Re: 2017-12-046: James Barber, 7 Touisset Rd., Warren RI, 02885, Residential Pier Application, AP 16, Lot 160

Submitted on behalf of the applicant, James Barber, please find enclosed revised plans to accompany application to construct & maintain a residential pier.

PROPOSED RESIDENTIAL PIER
 JAMES BARBER, 7 TOUISSET RD
 WARREN, RI
 AP 16, LOT 279
 BY: WARREN HALL, CIVIL ENGINEER
 SEPT. 8, 2020 SHEET 1 OF 4

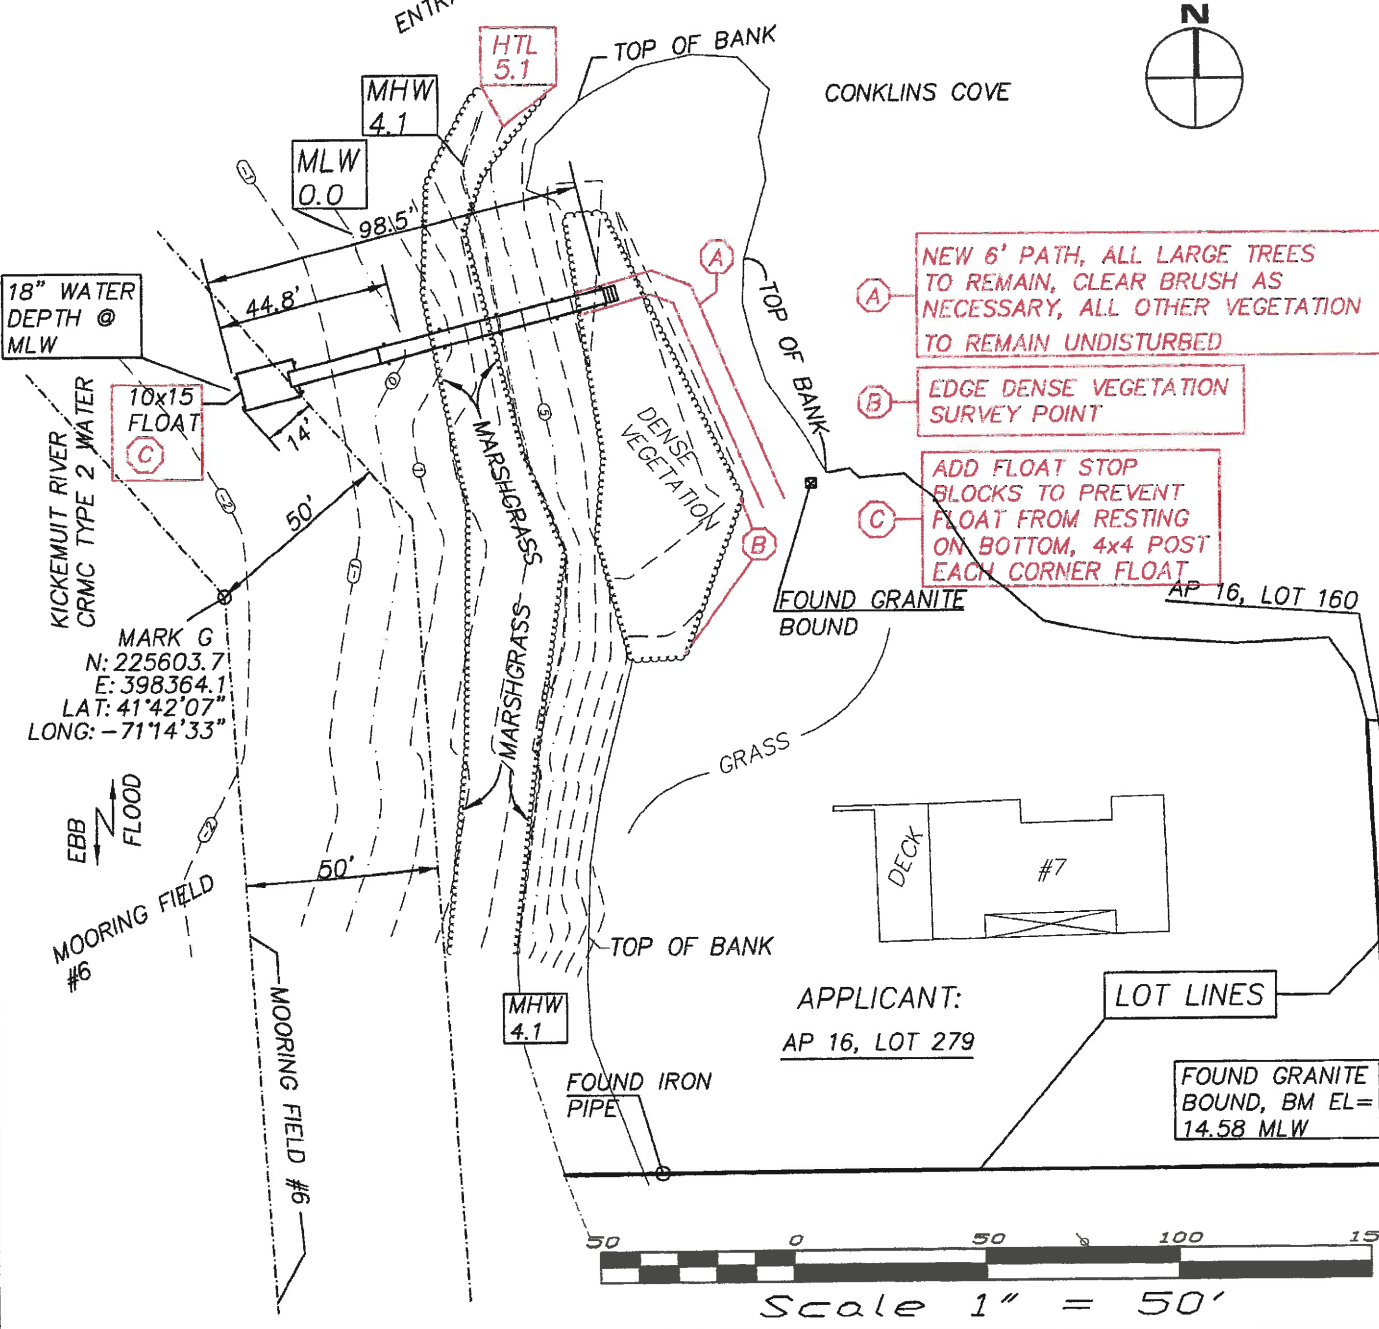
REVISION 2; 2-27-21 BY: WFH, ADD HTL, CLEAR THRU VEG.

SHEET 2 OF 4

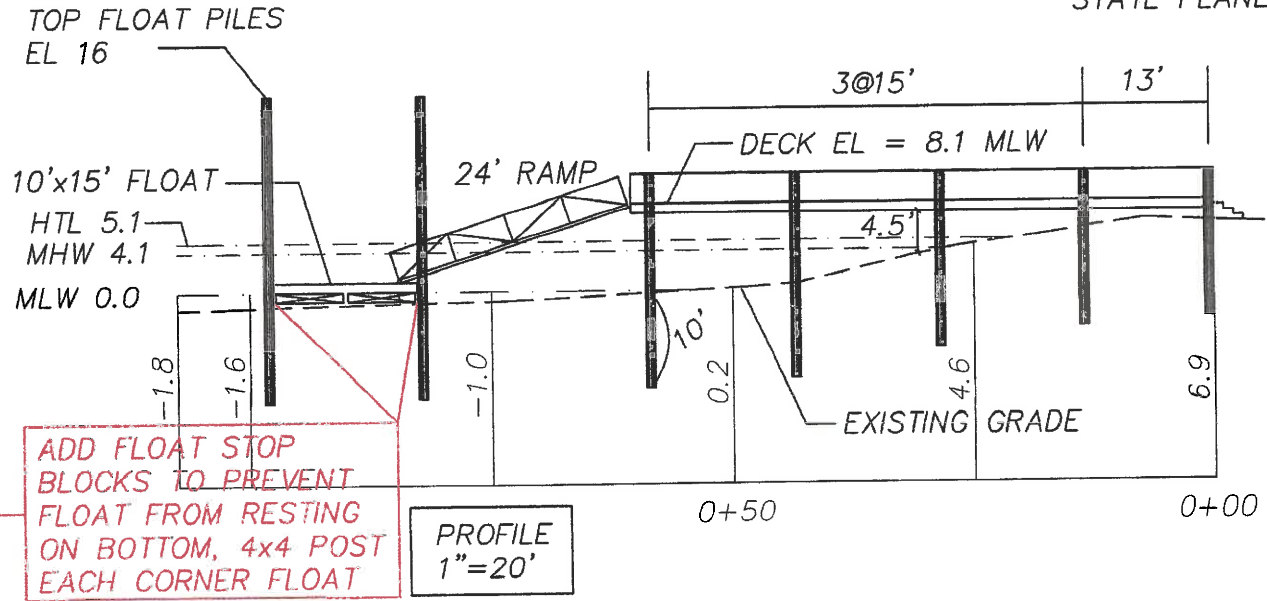
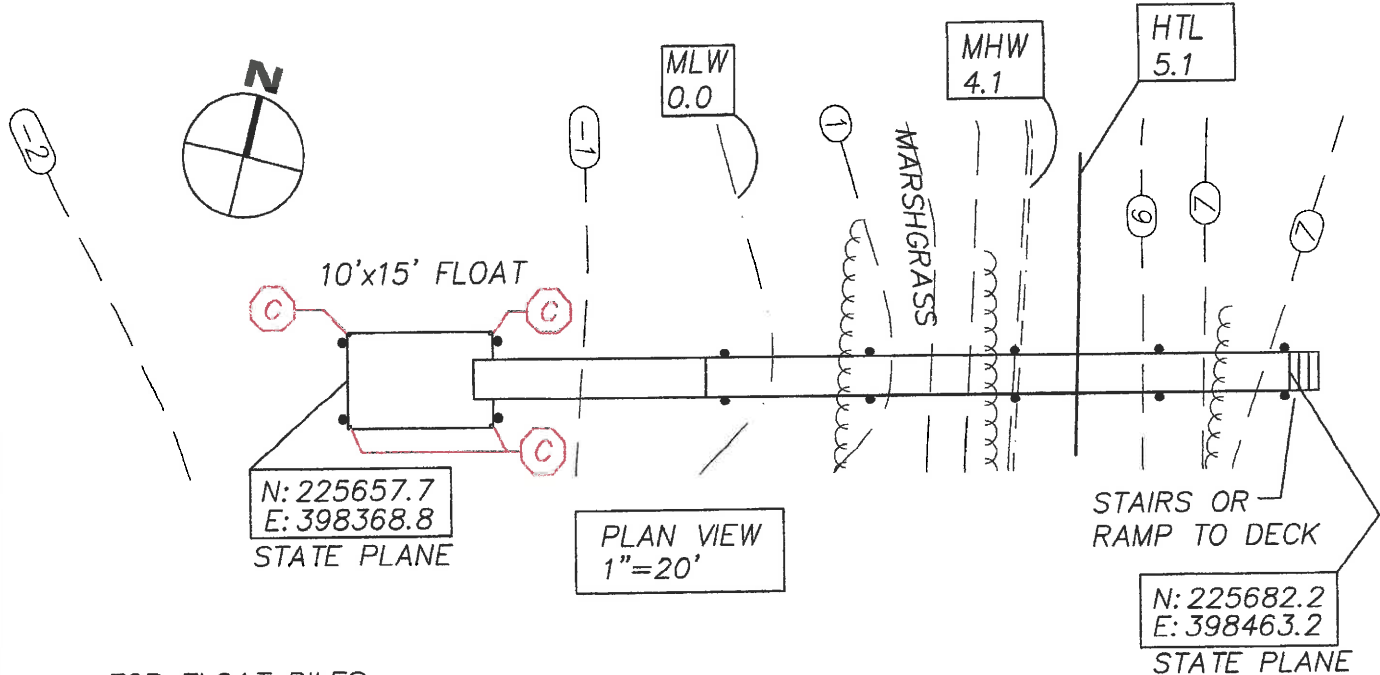
REVISION 2; 2-27-21 BY: WFH, ADD HTL, CLEAR THRU VEG.
